CNL-19-007

Browns Ferry Nuclear Plant, Units 1, 2, and 3
Renewed Facility Operating License Nos. DPR-33, DPR-52, and DPR-68
NRC Docket Nos. 50-259, 50-260, and 50-296

Subject: Proposed Technical Specifications (TS) Change TS-510 - Request for License Amendments - Maximum Extended Load Line Limit Analysis Plus - Supplement 5, Response to Requests for Additional Information

Responses to SRXB-RAI 1, 2, 3, and 4, SNPB-RAI-1a, and SRXB-C-RAI-6 in Support of BFN MELLLA+ LAR

**Figure 1 EOC LB LRNB at 100P/85F – TSSS
Key Parameters**

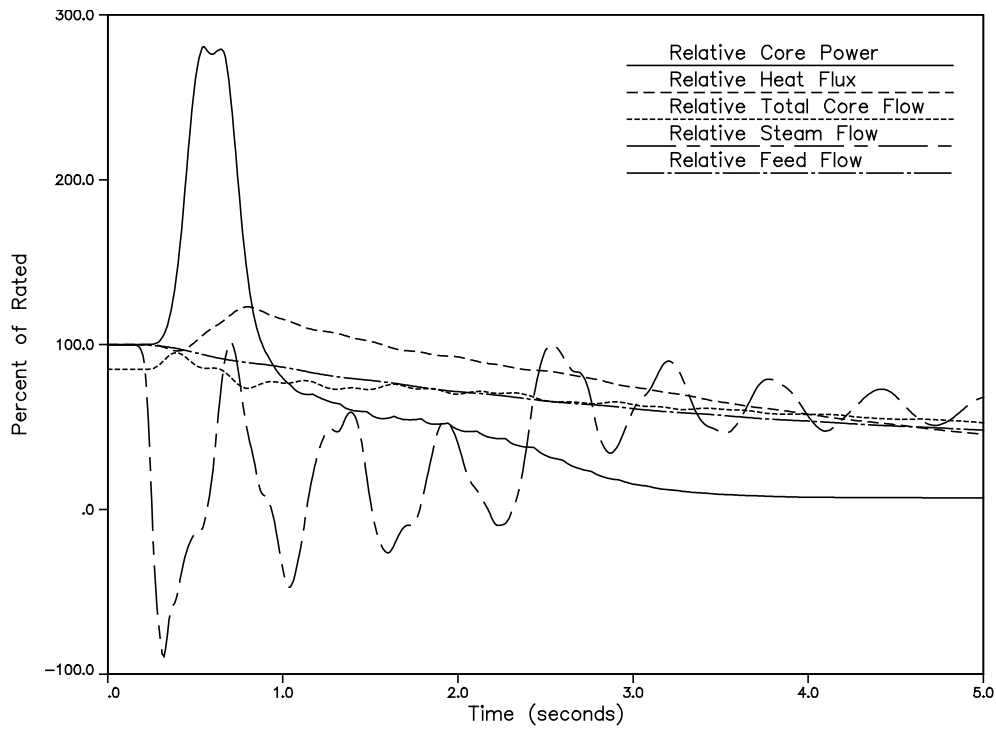
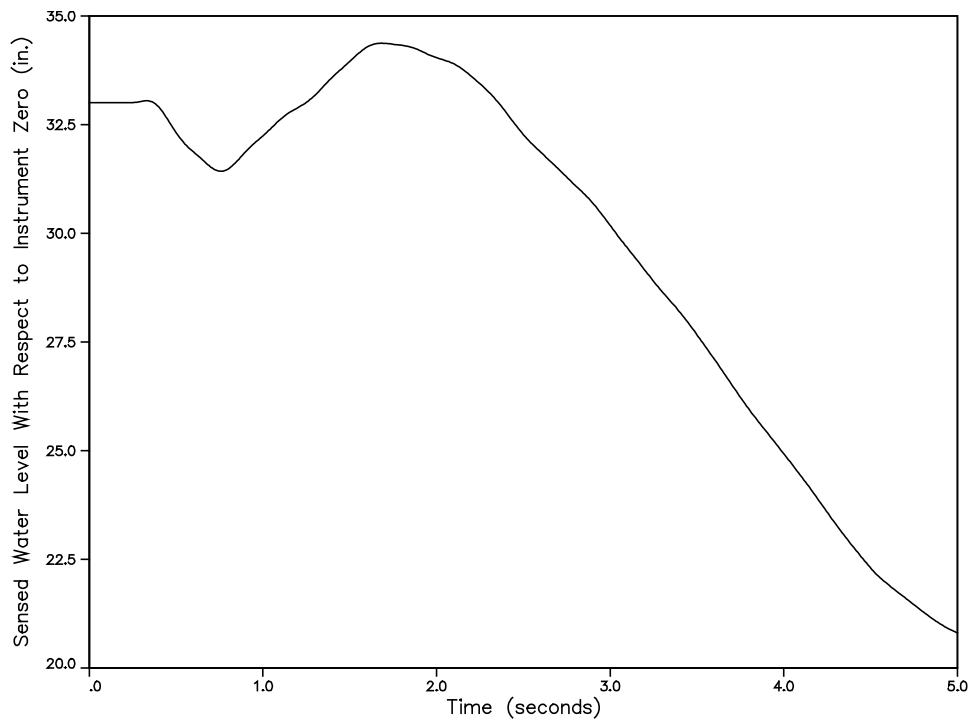
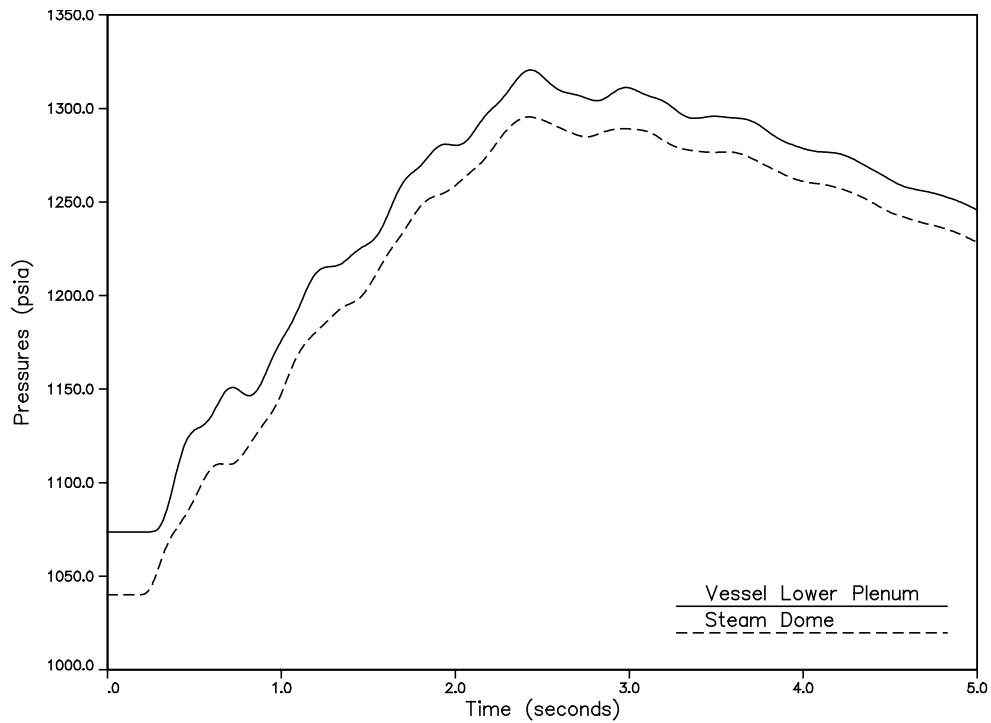
Provide the key parameter figures (like those in ANP-3552 Figures 5.1 through 5.6) for the 100 percent power and 85 percent core flow case for load reject no-bypass and the feedwater controller failure to understand the impact of MELLLA+ on these analyses to ensure they meet draft GDC 7. Discuss if the AOOs are reanalyzed each reload for all the MELLLA+ domain statepoints, and if not, describe why reanalysis is not necessary and what parameters are checked to ensure the original cases remain bounding (i.e., describe why the bounding analyses first analyzed for MELLLA+ will remain bounding in future cycles).*

Plots for the load reject no-bypass (LRNB) event and the feedwater controller failure (FWCF) at 100% rated core power, 85% rated core flow are shown in Figures 1 – 3 and Figures 4 – 6, respectively.

Figure SRXB RAI-5b-1

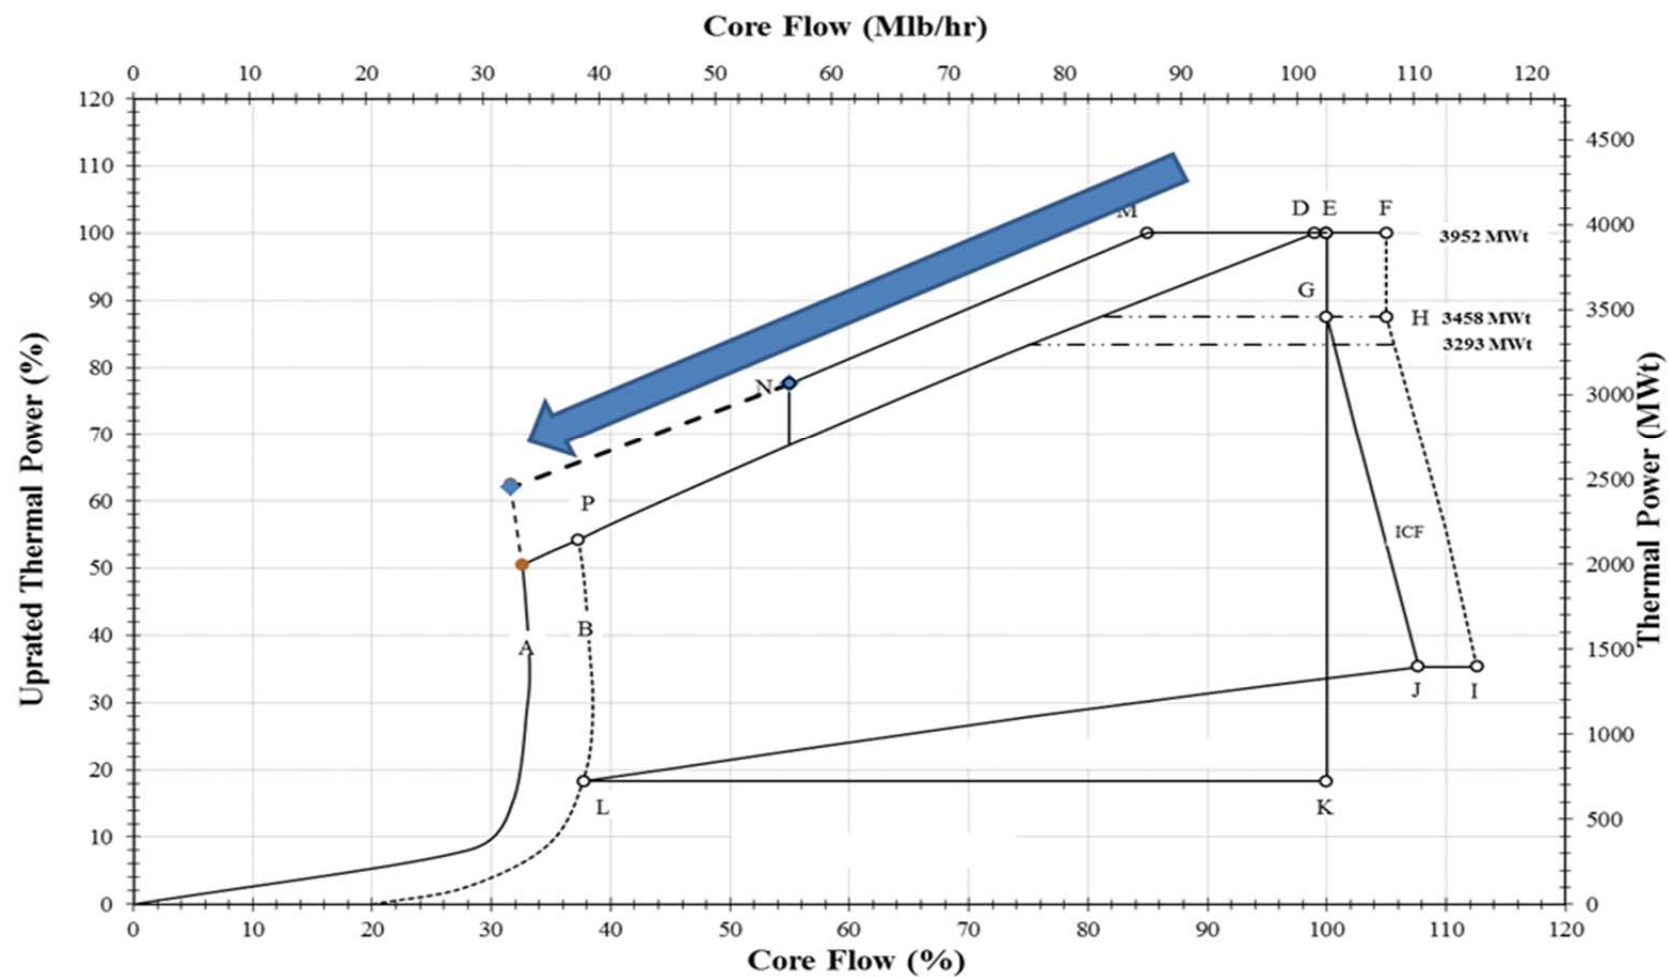
- a. Provide the basis for the 39,800 lbm used in the calculation which determined the 14 seconds delay time.*
- b. Justify that the 14 seconds delay time is bounding relative to the turbine trip event data for BFN, Unit 3.*
- c. Explain why the feedwater temperature reduction rate changes during the turbine trip event at BFN, Unit 3 (Step 1, Step 2, and Step 3) and please discuss why this is bounding for ATWS-I.*
- d. Please compare the TRACG feedwater temperature input to ATWS simulator data to demonstrate that the feedwater temperature used in the analysis is conservative.*
- e. Please provide justification that this basis is also applicable to the feedwater temperature reduction for the 2RPT event.*

Based on rated FW flow (i.e., 16.4 Mlbm/hr) and assuming 62% power (i.e., reactor power at reactor natural circulation), the mass of FW required during the first 120 seconds of a high-power ATWS event is just under 339,000 lbm. Figure SRXB RAI-5c-3 shows the change in FW temperature on a per unit mass basis for the 2004 BFN Unit 3 turbine trip event compared to the change in FW temperature on a per unit mass basis for the assumed FW temperature reduction used in the BFN TTWBP ATWS-I event. Observation of the data plotted in Figure SRXB RAI-5c-3 provides additional confidence that the assumed FW temperature reduction rate used in the BFN TTWBP ATWS-I analysis bounds the expected BFN plant response. As noted in part b of this RAI response, the power reduction and corresponding FW flow reduction to natural circulation conditions is not instantaneous. This would result in a slightly higher mass of FW injected during the first 120 seconds of a high-power ATWS event. However, this larger mass of FW injection does not alter the conclusion drawn from Figure SRXB RAI-5c-3 that the assumed FW temperature reduction rate used in the BFN TTWBP ATWS-I analysis bounds the expected BFN plant response.
